January 12, 2015

ADDENDA: 1

Petersburg Library Landscape Plans

The following items outline work changes in Addenda #1:

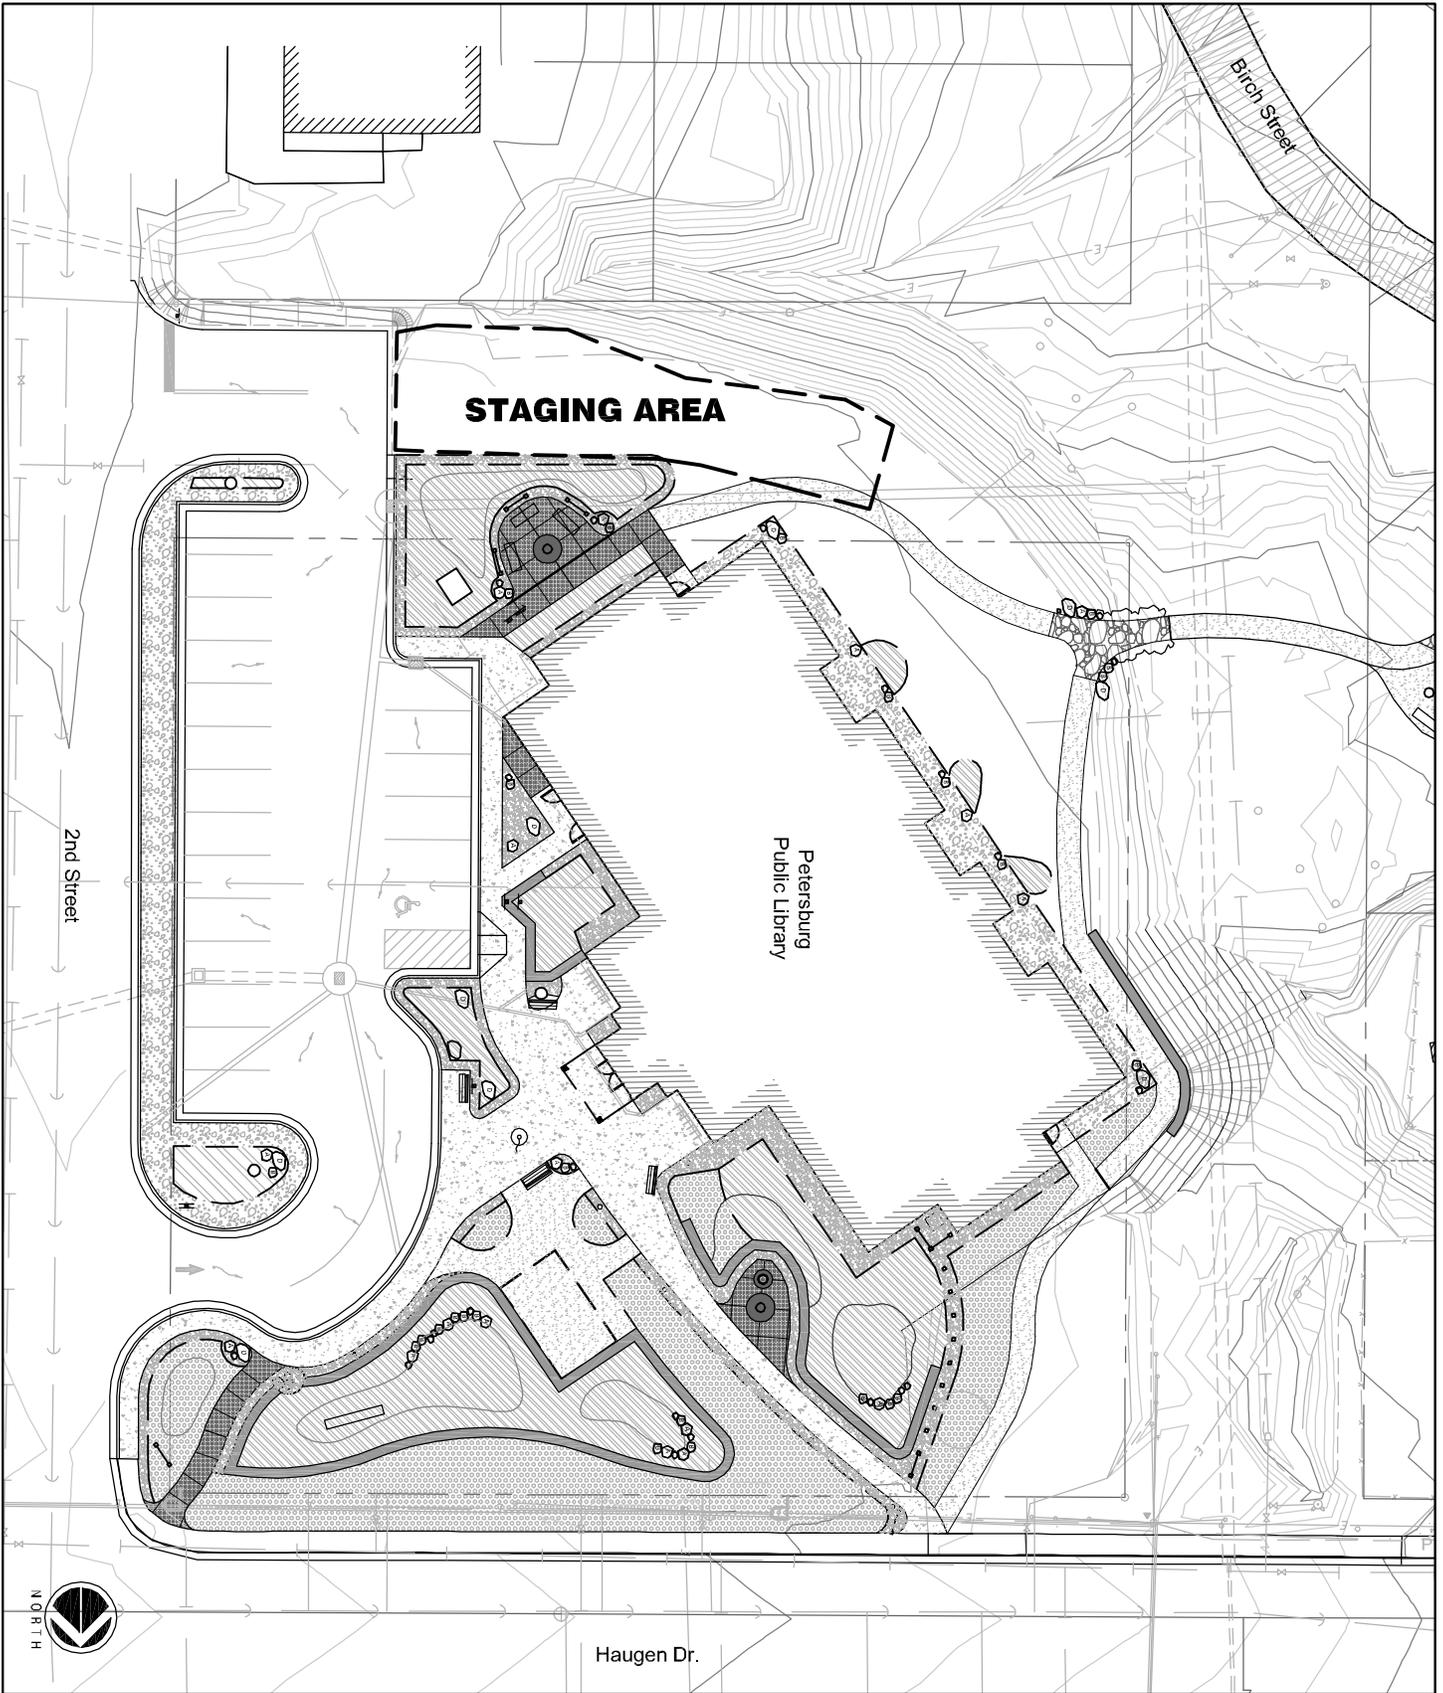
1. Staging Area: The area south of the building in the ROW is allocated for construction staging. Egress from the library parking lot should be maintained as well as access to the Thompson Building parking on their north side. See attachment A.
2. Sheet L205 Alternate 4 - Revised trail end/connection to Birch Street: The trail end has been shifted 10' to the north to be entirely on Borough property. See attachment B, revised Sheet L205.
3. Owner furnished medallion: Owner furnished medallions are located at the Petersburg Borough Public Works Department. Medallions are in existing cast concrete. 'Raven/Eagle' medallion to be placed in NW concrete node by the Children's Room (Sheet L203). 'Berries' medallion to be placed in S concrete node by the multi-purpose Room for Alternate 2 (Sheet L204). Example of existing conditions at the yard below.

ATTACHMENT C

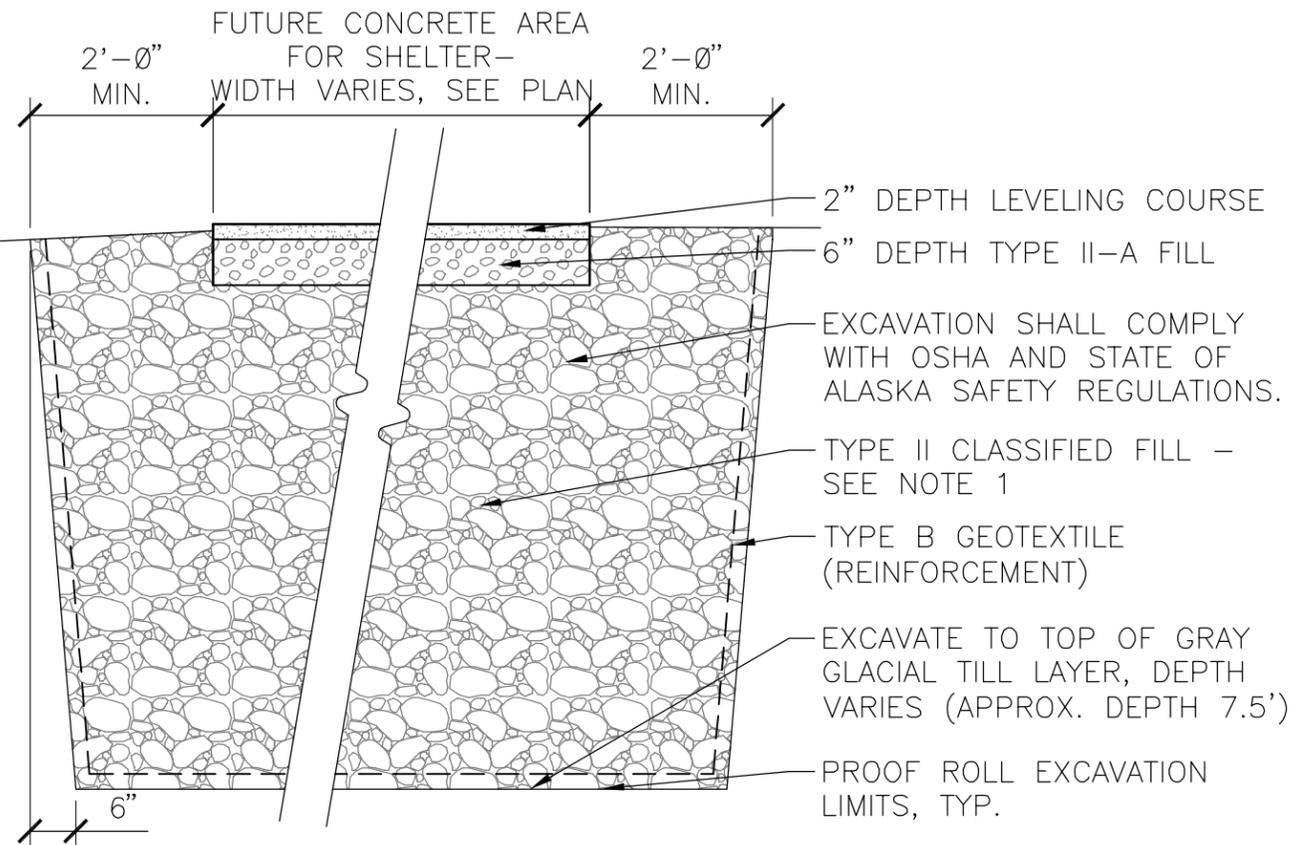
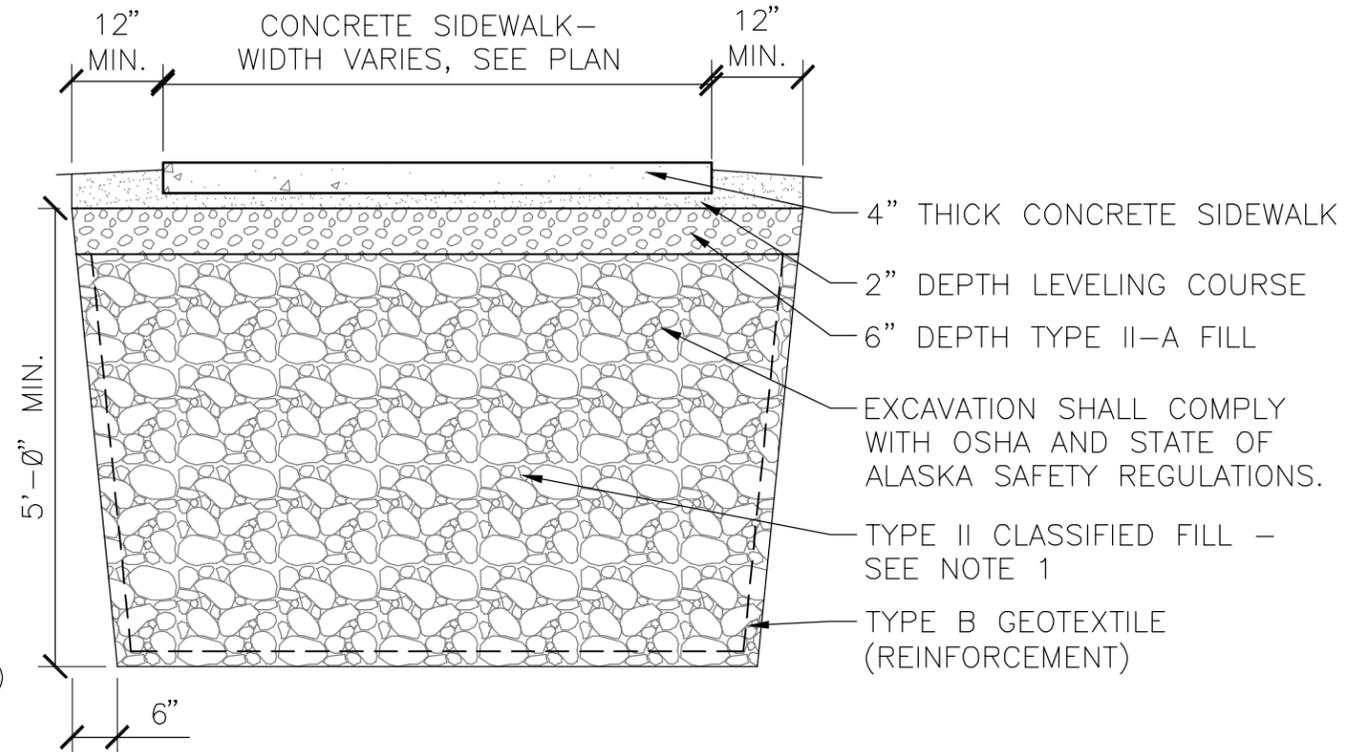
6. Excavation/Backfill Limits: See attachment C for new concrete sidewalk detail and future shelter area detail. Shot rock fill that was placed for building and roadway foundations may project into new concrete areas and material should be lapped. Shoring/Bracing in accordance with Standard Specification Section 20.30 may be needed to prevent undermining of adjacent pavements. Test holes to determine the existence, depth and extent of previous rock fills may be required to prevent replacement of suitable material.
7. Rock Wall: See attachment D for revised Rock Wall excavation/fill requirements.

1. A MINIMUM LIFT OF 24" IS PERMITTED WHEN FILL IS PLACED OVER THE INITIAL SUBGRADE IN ACCORDANCE WITH STANDARD SPECIFICATION 20.21.
2. SHOT ROCK FILL THAT WAS PLACED FOR BUILDING AND ROADWAY FOUNDATIONS MAY PROJECT INTO FUTURE CONCRETE AREA AND FILL MATERIAL SHALL BE LAPPED.
3. SHORING/BRACING IN ACCORDANCE WITH STANDARD SPECIFICATION 20.30 MAY BE NEEDED TO PREVENT UNDERMINING OF ADJACENT PAVEMENTS.

1. A MINIMUM LIFT OF 24" IS PERMITTED WHEN FILL IS PLACED OVER THE INITIAL SUBGRADE IN ACCORDANCE WITH STANDARD SPECIFICATION 20.21.
2. SHOT ROCK FILL THAT WAS PLACED FOR BUILDING AND ROADWAY FOUNDATIONS MAY PROJECT INTO NEW CONCRETE AREAS AND FILL MATERIAL SHALL BE LAPPED.
3. SHORING/BRACING IN ACCORDANCE WITH STANDARD SPECIFICATION 20.30 MAY BE NEEDED TO PREVENT UNDERMINING OF ADJACENT PAVEMENTS.
